Title - Sujet Fire Protection Repairs	
Solicitation No. - N° de l'invitation F1571-175061/A	Amendment No. - N° modif. 001
Client Reference No. - N° de référence du client F1571-175061	Date 2017-11-30
GETS Reference No. - N° de référence de SEAG PW-\$PWY-020-8230	
File No. - N° de dossier PWY-7-40261 (020)	CCC No./N° CCC - FMS No./N° VME
Solicitation Closes - L'invitation prend fin at - à 02:00 PM on - le 2017-12-06	
Time Zone Fuseau horaire Pacific Standard Time PST	
F.O.B. - F.A.B. Plant-Usine: <input type="checkbox"/> Destination: <input checked="" type="checkbox"/> Other-Autre: <input type="checkbox"/>	
Address Enquiries to: - Adresser toutes questions à: Ly, Ronny(PWY)	Buyer Id - Id de l'acheteur pwy020
Telephone No. - N° de téléphone (604) 318-5750 ()	FAX No. - N° de FAX (604) 775-6633
Destination - of Goods, Services, and Construction: Destination - des biens, services et construction: DFO - Port Edward Harbour - Port Edward, BC

Port Edward – Fire Protection Repairs Addendum #1

Drawing No.
PE-010

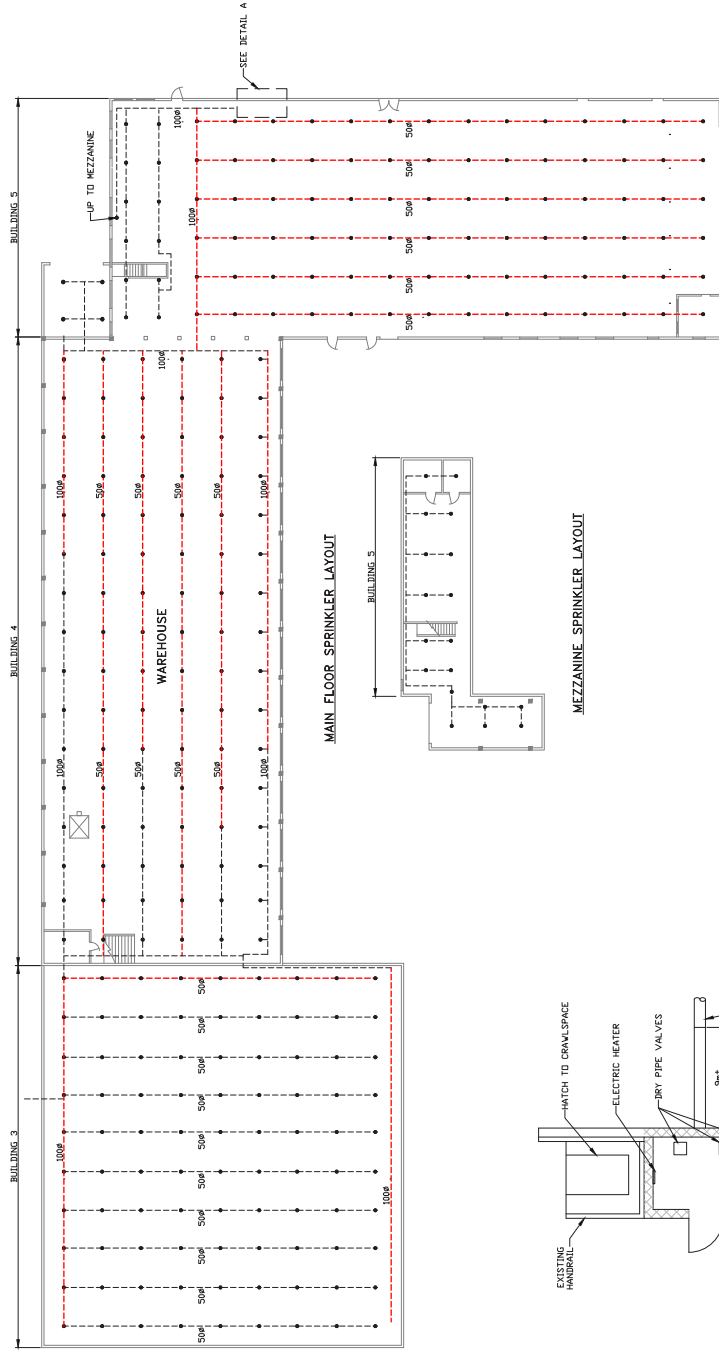
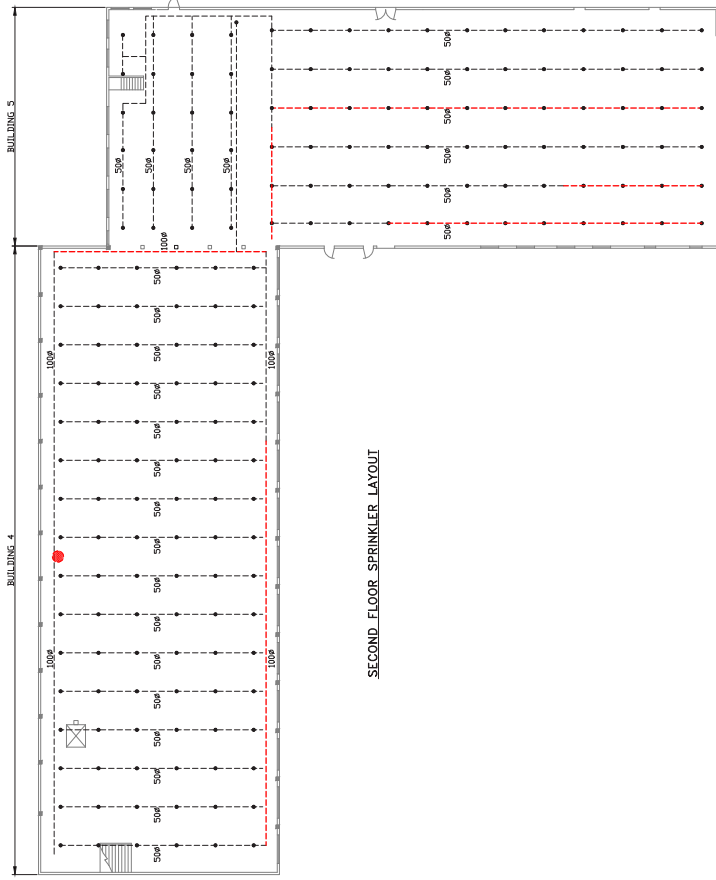
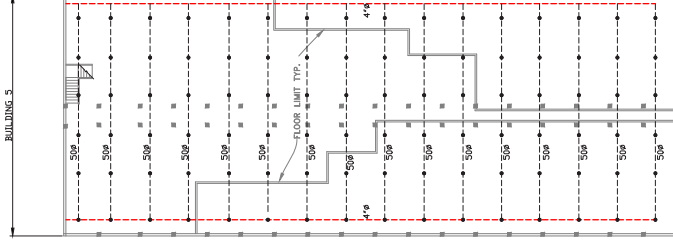
- Supply and install the following sprinkler head, or owner approved equivalent.
 - Victaulic Firelock Model V2703, Commercial Storage, K 5.6, Upright, Standard Response, 200°F, Approval class cULus, FM, VDS, LPCB, CE, CCCF, Brass 250psi / 17 bar.
 - Sprinklers installed in-line at 3.1m (10') spacing with Victaulic mounts.
- 2. The reference drawing 703411 “Port Edward, BC – Buildings New Fire Exits – Floor Plans – Buildings 1001, 1002, &1003 / Buildings 1004 & 1005” to be replaced with the following drawing,**

Drawing Title
Port Edward, BC - Harbour Buildings Warehouse, Building No
3,4,&5 - Sprinkler Layout (SH 1&2)
